Engineering Review
 03/11/2021 2:18:44 PM
 dsdrice
 JeffRice@elpasoco.com
 (719) 520-7877
 EPC Planning & Community
 Development Department

PCD-ENGINEERING REVIEW COMMENTS
 IN BLUE BOXES WITH BLUE TEXT

PRELIMINARY SITE GRADING CONSTRUCTION PLANS
 FOR
SKYLINE AT LORSON RANCH

EARLY OVERLOT GRADING / EROSION CONTROL PLANS

TYPICAL "A" LOT

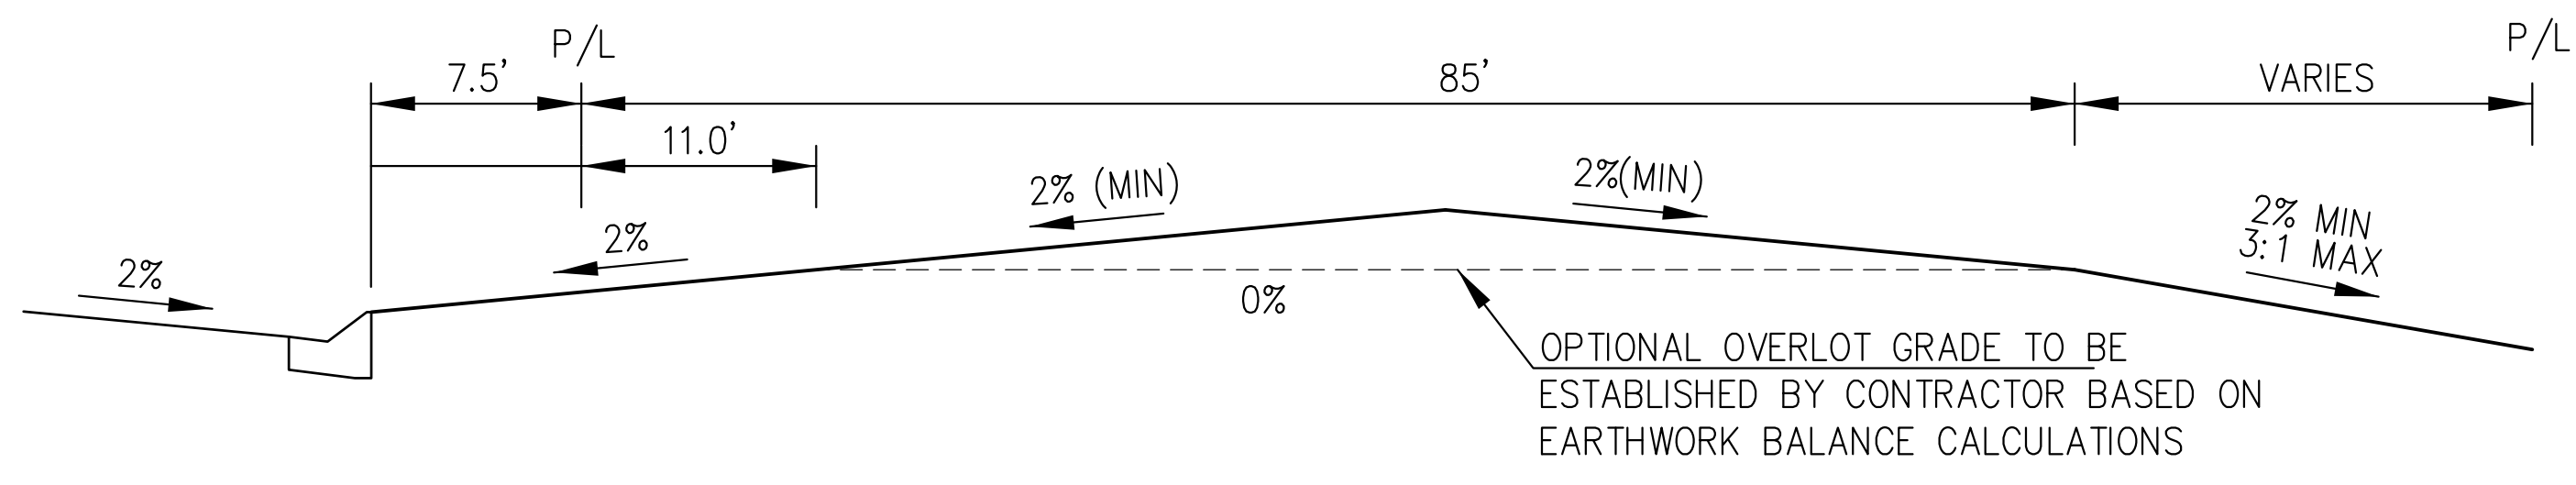
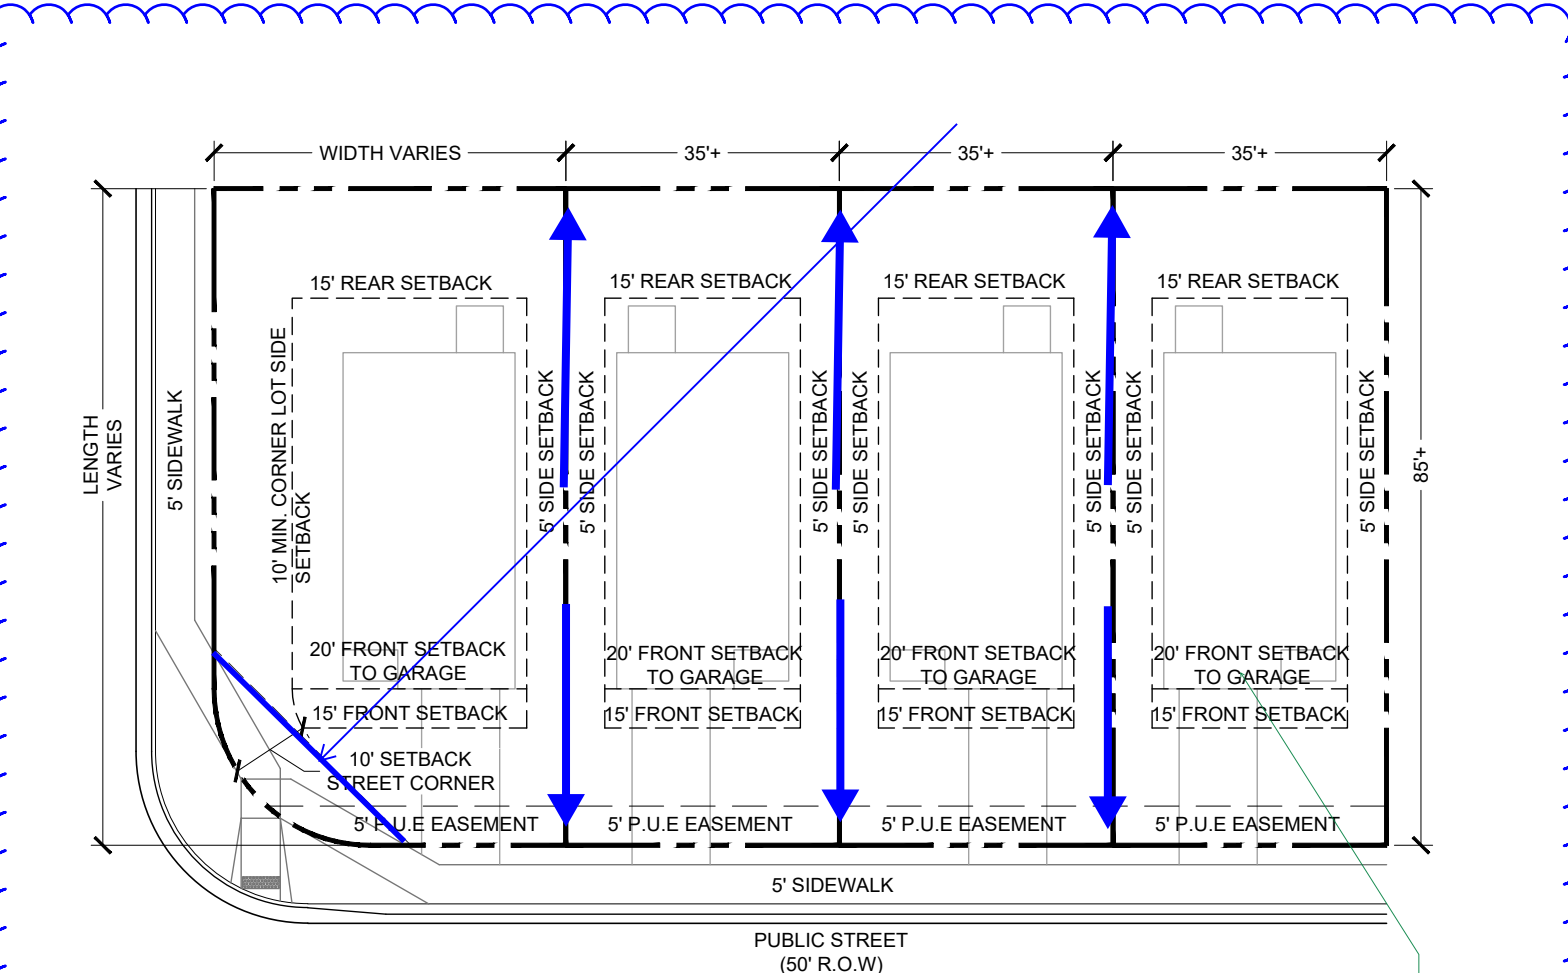
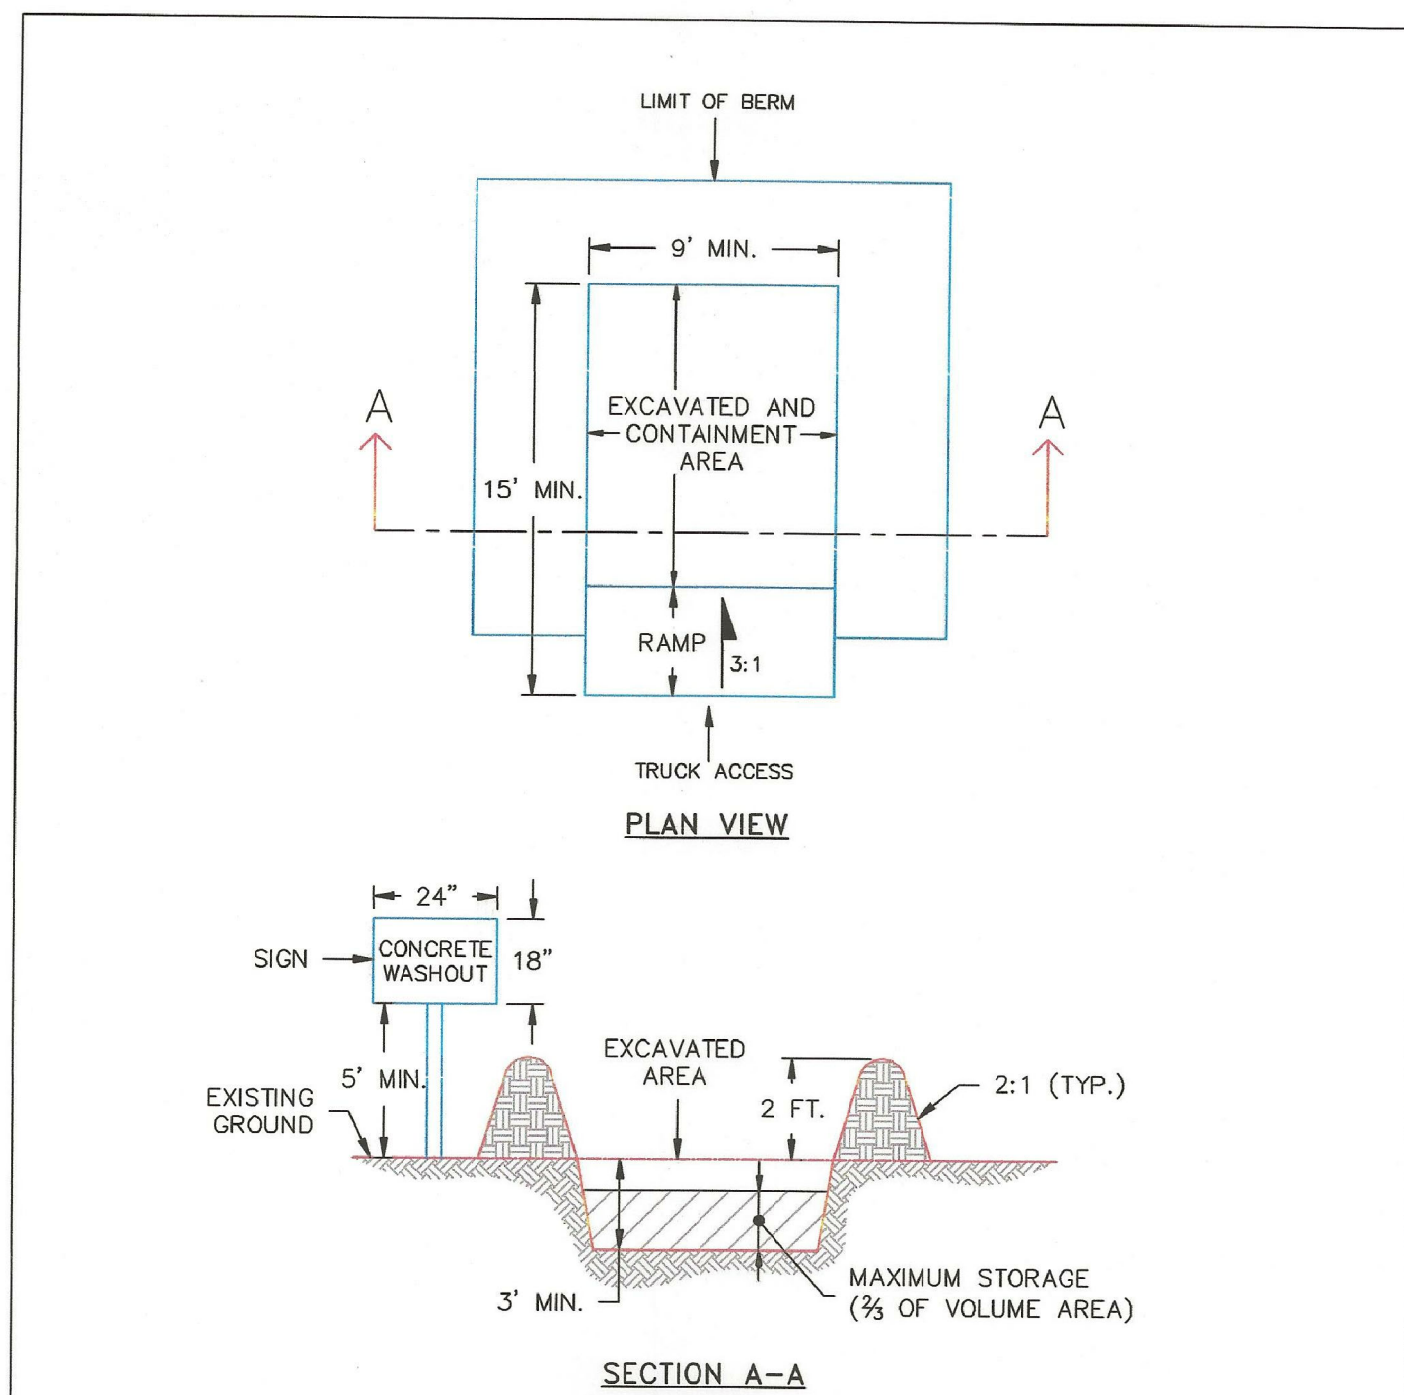
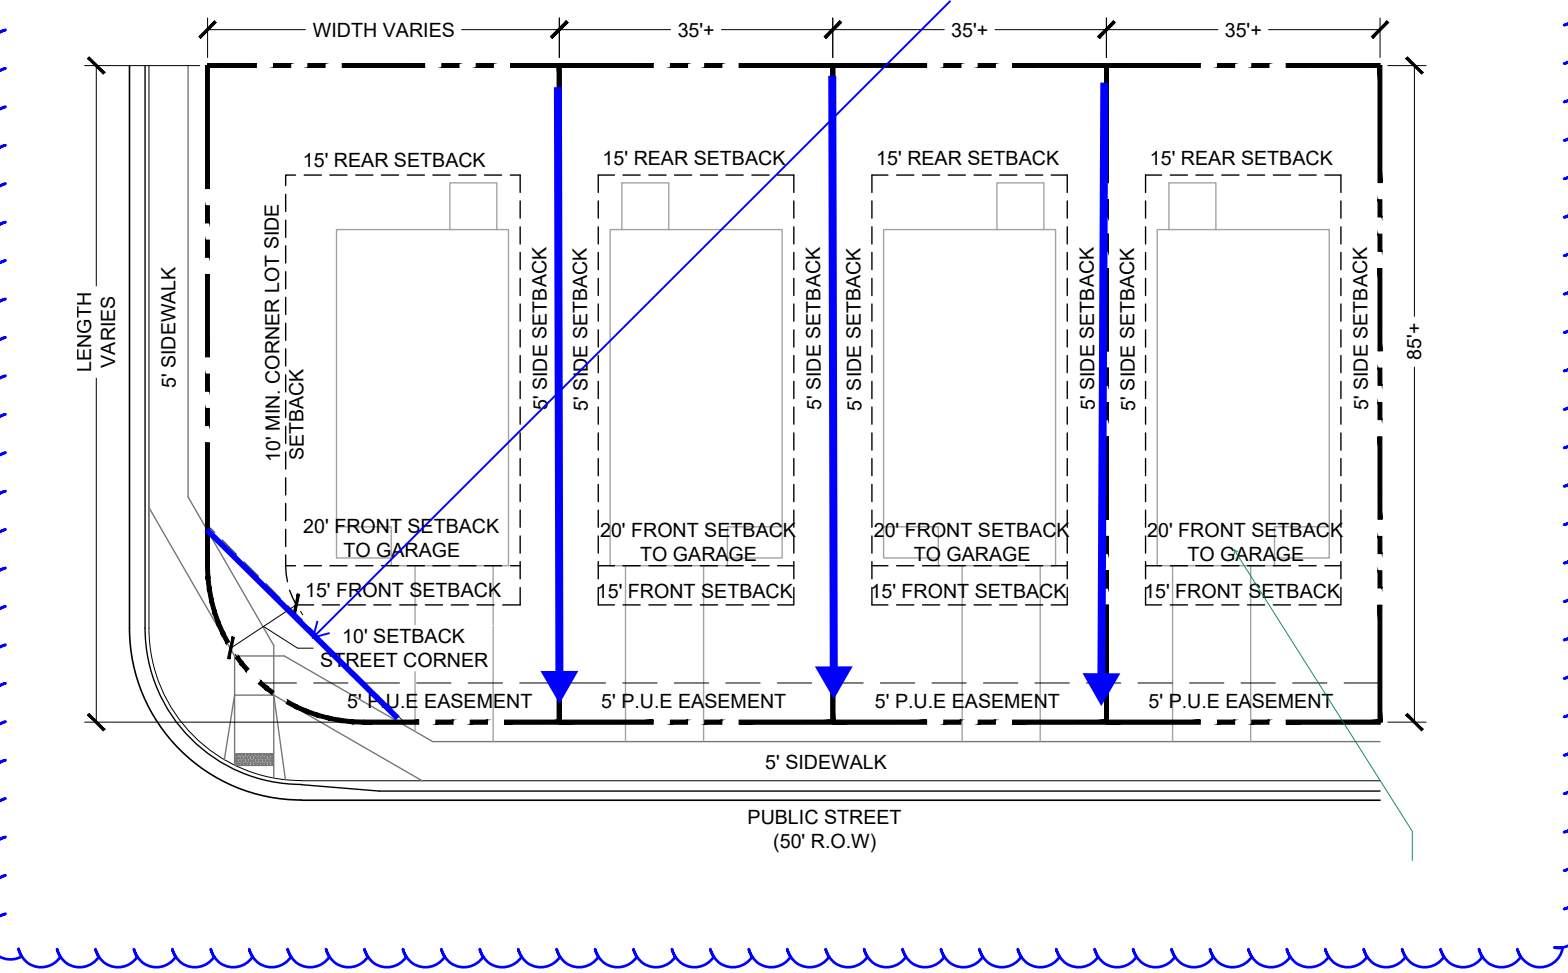
Provide details showing side-lot swales required of builders and typical section of swale between lots.

ST-2 Sediment Trap (ST) November 2010

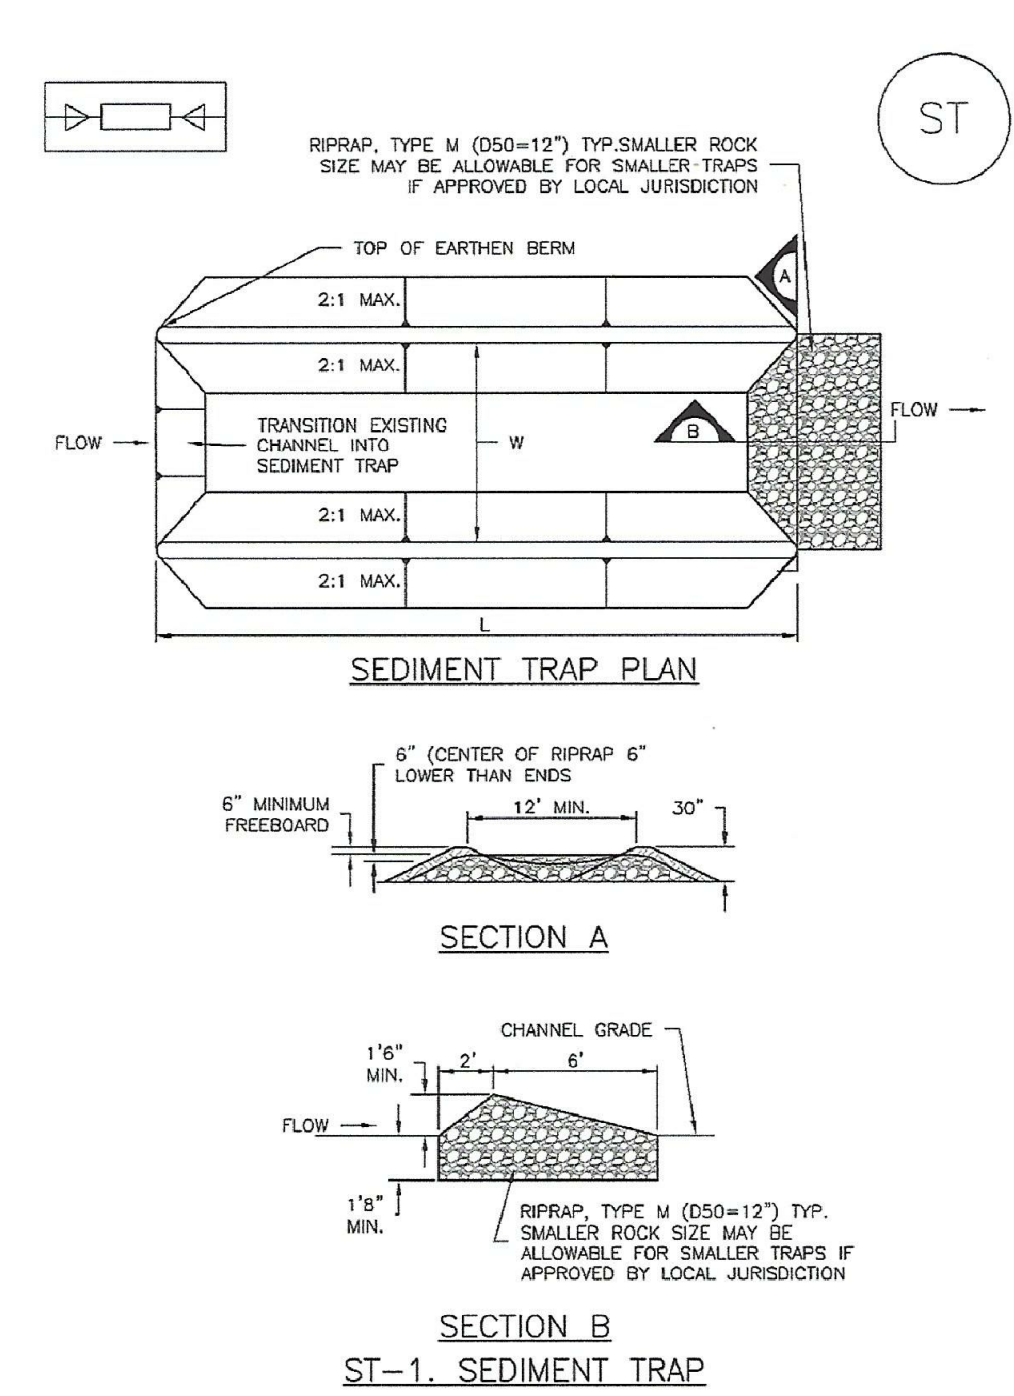
Replace with Sediment Basin. Provide details of temporary sediment basin, including riser pipe perforation sizing, number of rows, required volume, and tributary area to the sediment basin.
